Responses to Reviewer Comments on “Effect of tip spacing, thrust coefficient and turbine spacing in multi-rotor wind turbines and farms”

Niranjan S. Ghaisas, Aditya S. Ghate, Sanjiva K. Lele

1 Response to Reviewer 1

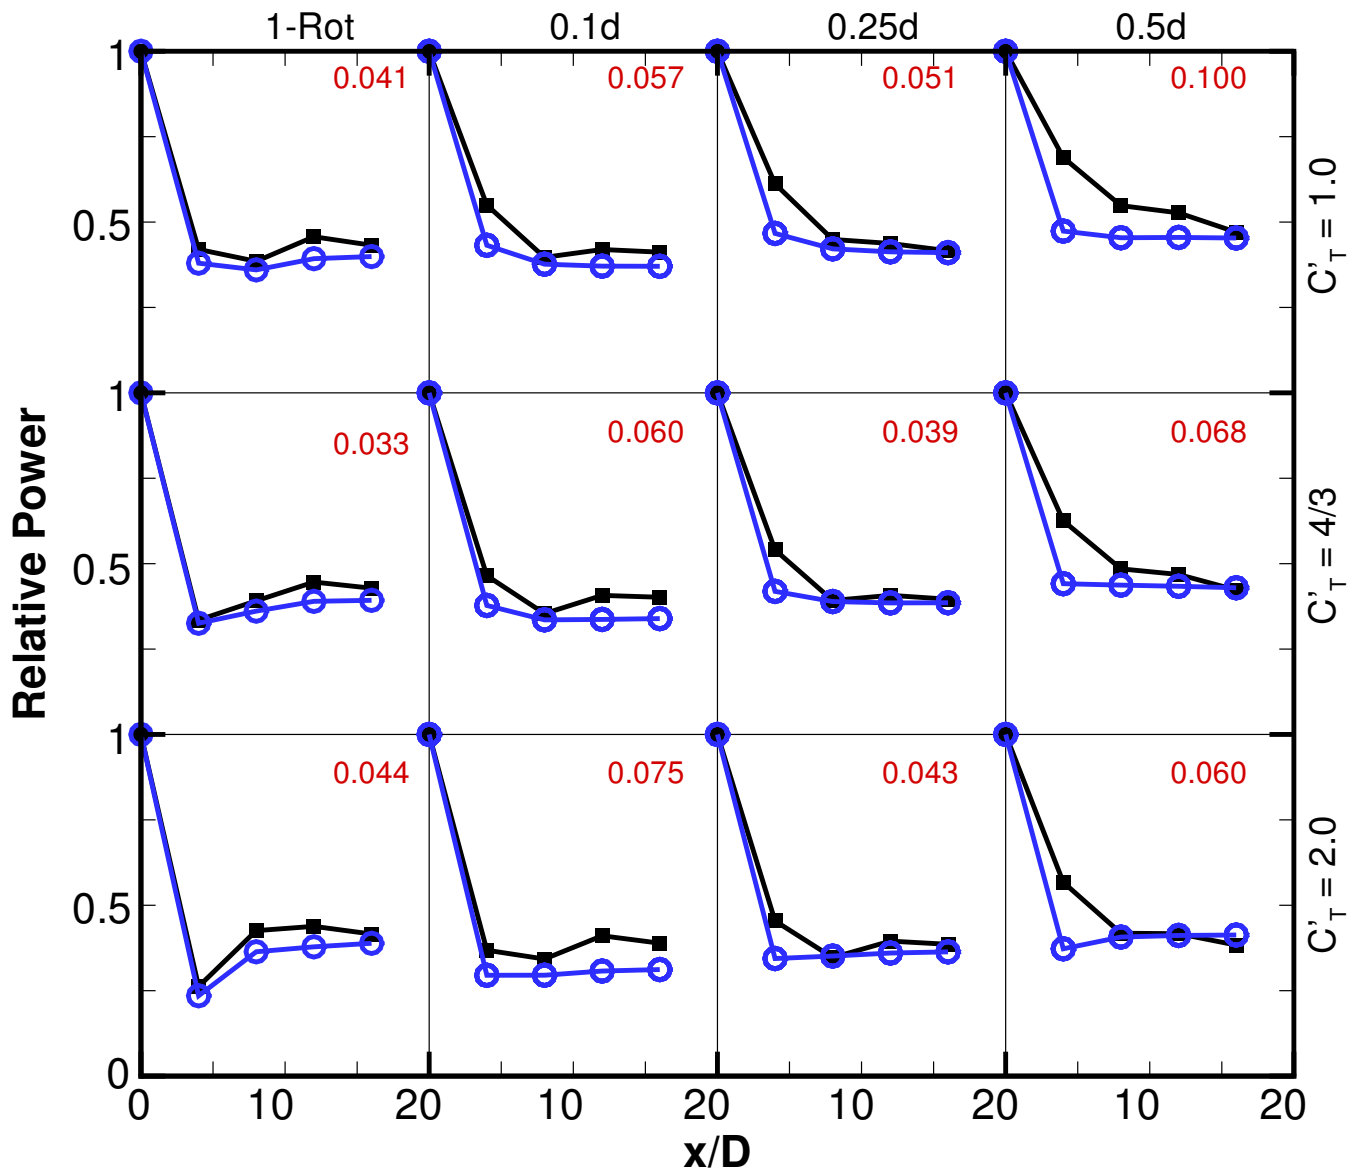
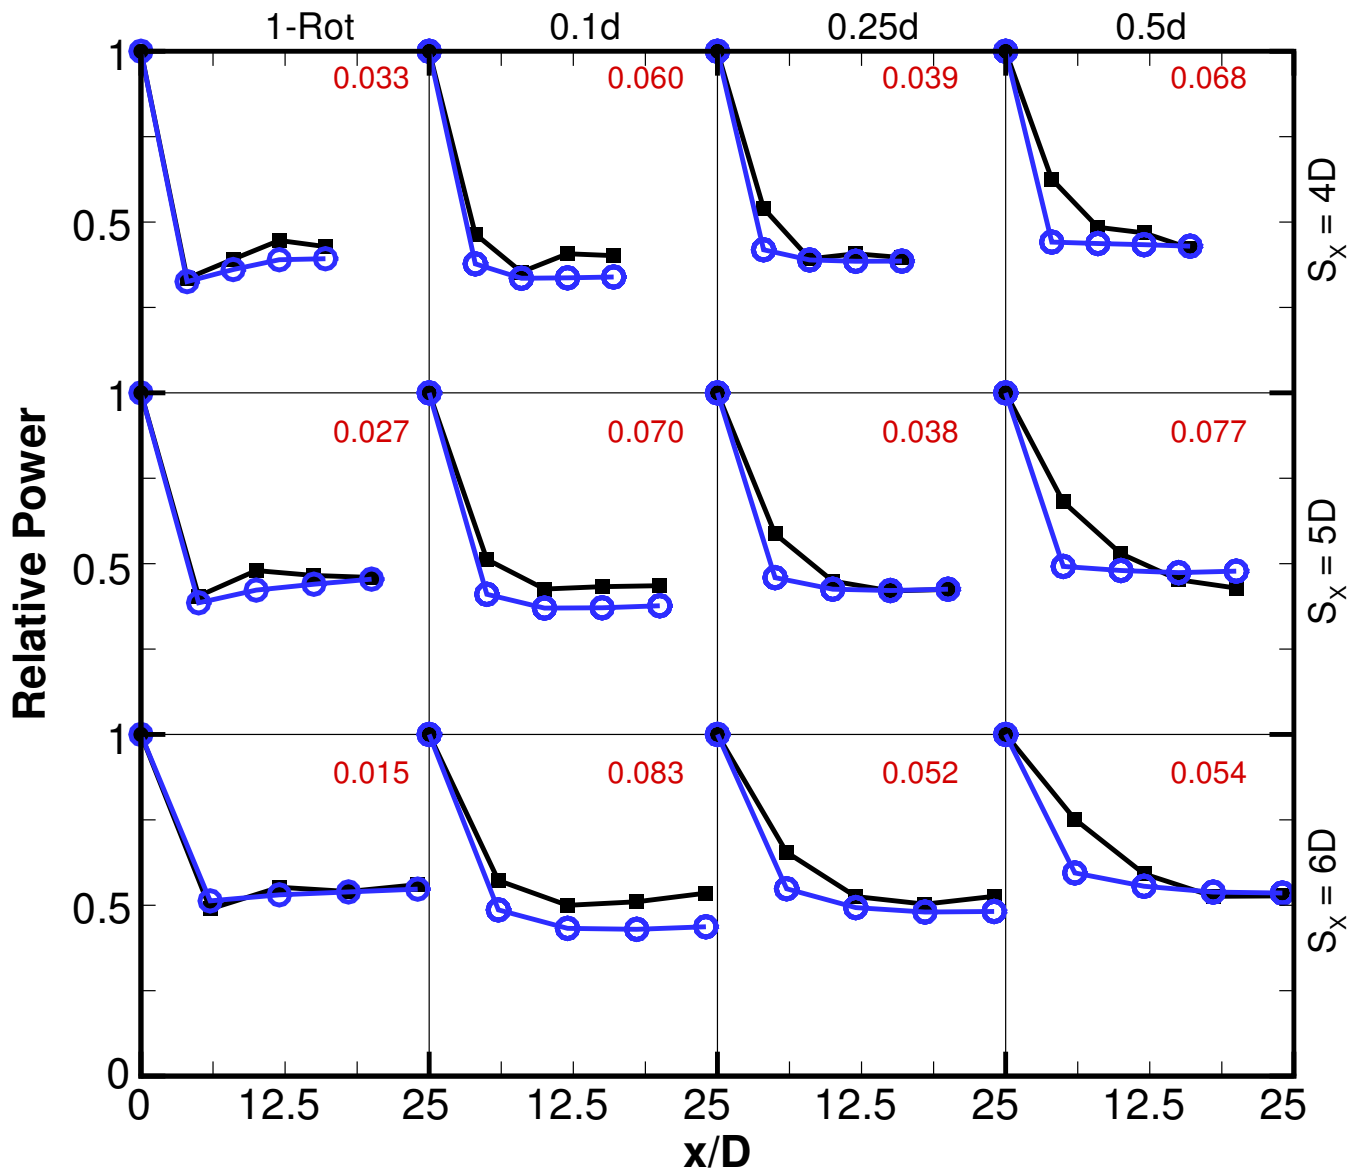
- p. 21-22, Fig. 14-15: Please include explanation of the red values and how they are computed. Figures should be self-contained.

Response: The red values are the absolute error between the LES result and the model prediction of the relative power, computed at each of the four downstream turbines (turbines 2 through 5), and then averaged. Thus, the numbers in red in Figures 15 and 16 are $(1/4) \sum_{i=2}^5 |(P_i/P_1)^{LES} - (P_i/P_1)^{model}|$. The formula for the error is included in the revised manuscript on line 375 and in the figure captions.
